UNITED STATES
NUCLEAR REGULATORY COMMISSION
REGION II
101 MARIETTA STREET, N.W.
ATLANTA, GEORGIA 30323

Report No.: 50-302/89-17

Facility Name: Crystal River 3

Inspection Conducted: June 19-20, 1989

FIGURE 1

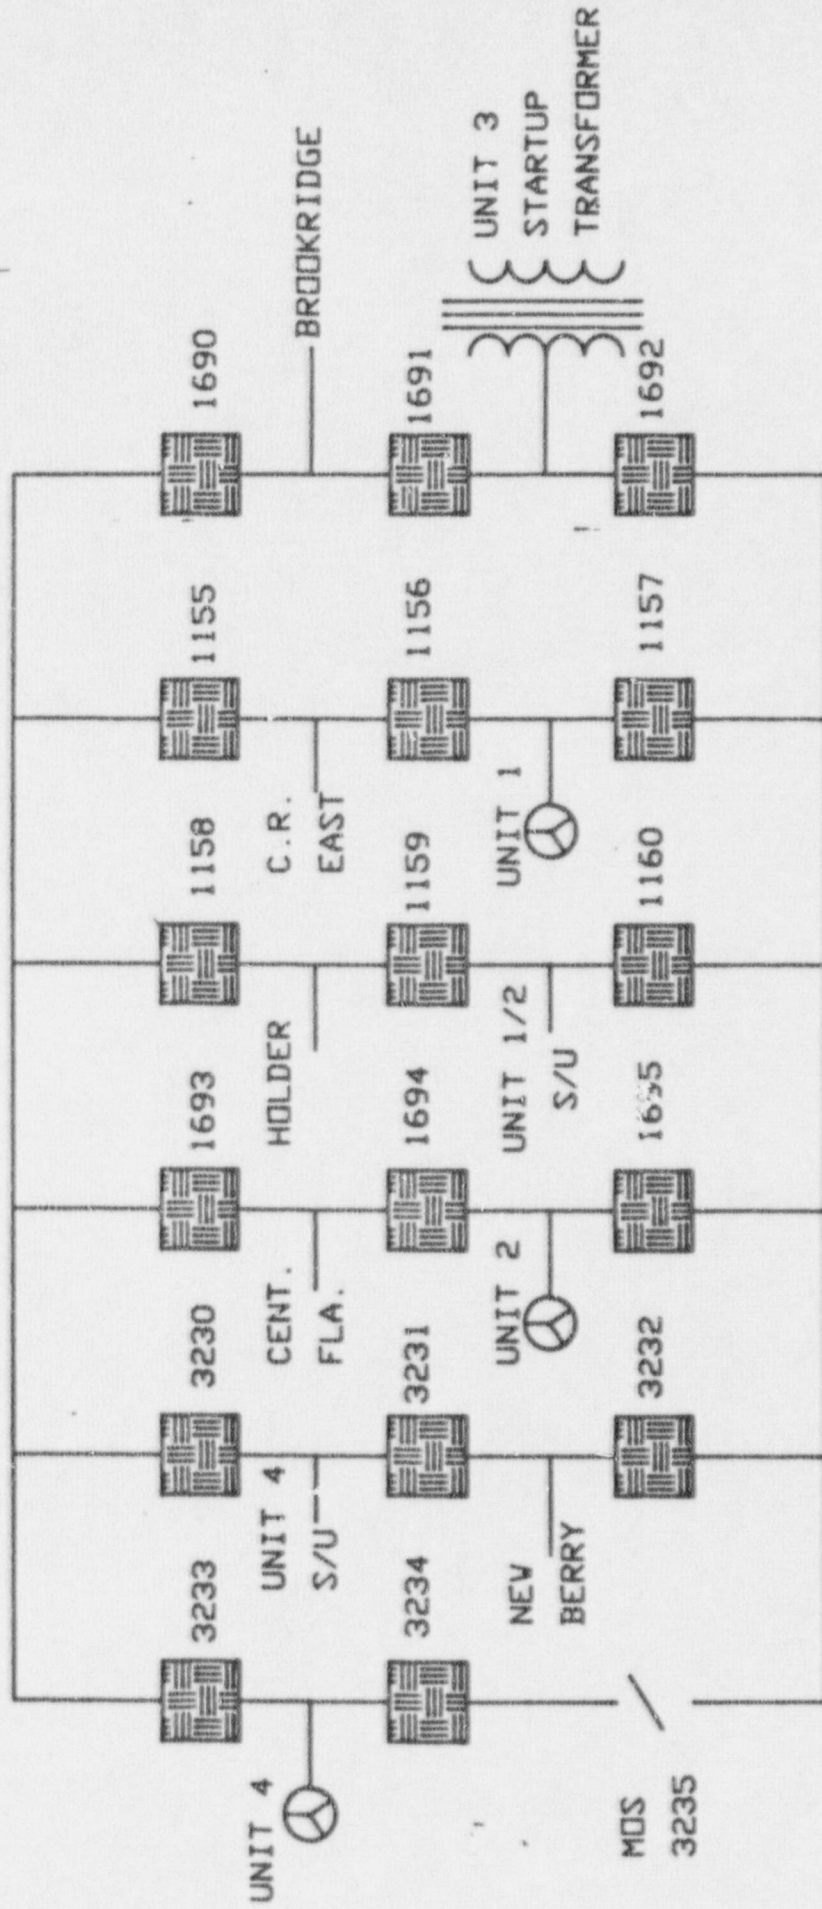
Increased management attention to control the interface between the Units 1 and 2, switchyard and the Unit 3 Start-up transformer is needed. The current plant design relies solely on the Unit 3 Start-up transformer as the primary source of power to the Emergency System and Unit buses. An additional source of off-site power would enhance the response to a single failure of the Unit 3 transformer. Additionally, during the event of June 16, 1989, the Emergency Feedwater Pump-1 failed to automatically start after the Emergency Diesel Generator powered the Emergency Buses. This failure may have been prevented had proper testing of the logic string for this sequence been tested. The inadequate testing was not identified during the root cause analysis completed by the licensee.

A list of acronyms and initialisms used herein is provided at the end of this report. Figures 1 and 2 outline the Crystal River off-site power supplies.

The NRC's 1974, SER states the CR-3 off-site power is from two separate feeders emanating from different breaker-and-a-half configuration bays in the 230KW switchyard. These power source are connected to two separate

Start-up transformers of which one is assigned to CR-3 and the other is shared between CR-1, 2, and 3. The shared Start-up transformer, feeder lines and associated breakers have sufficient capacity to handle all required load demands from the three units. The TS for CR-3 states that these two physically independent circuits between the off-site transmission network and the on-site ES bus are to be available for CR-3, when in operating Modes 1, 2, 3, and 4 (as defined in the TS). The TS also gives requirements that must be fulfilled when the conditions are not met.

FIGURE 2

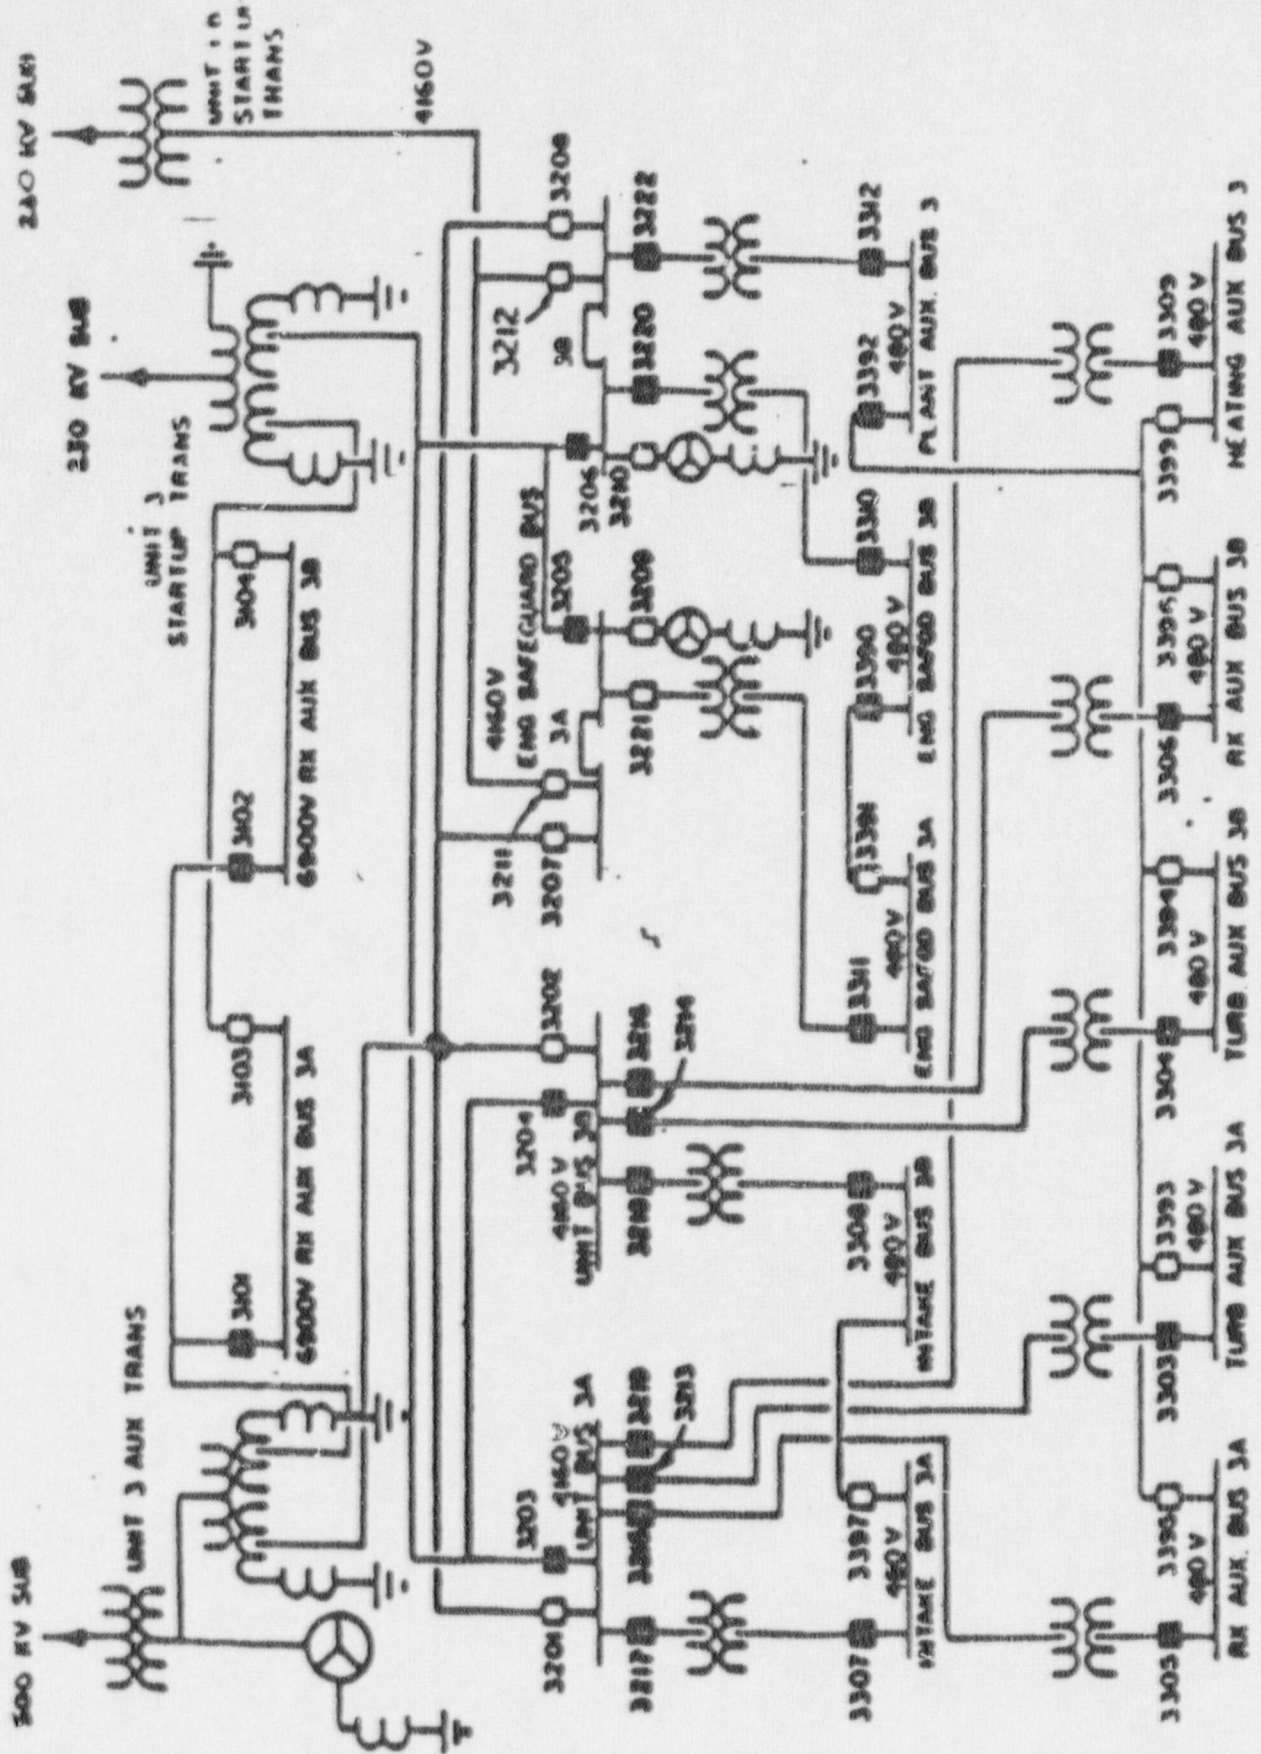
The FSAR states that the preferred off-site power source for CR-3's ES buses is the Unit 3 Start-up transformer and the alternate and independent source is the Units 1 and 2 (Fossil Units) Start-up transformer via a direct cable connection. Transfer to the alternate source is by manual operations. The on-site Emergency Diesel Generators assume the ES bus loads in the following manner:
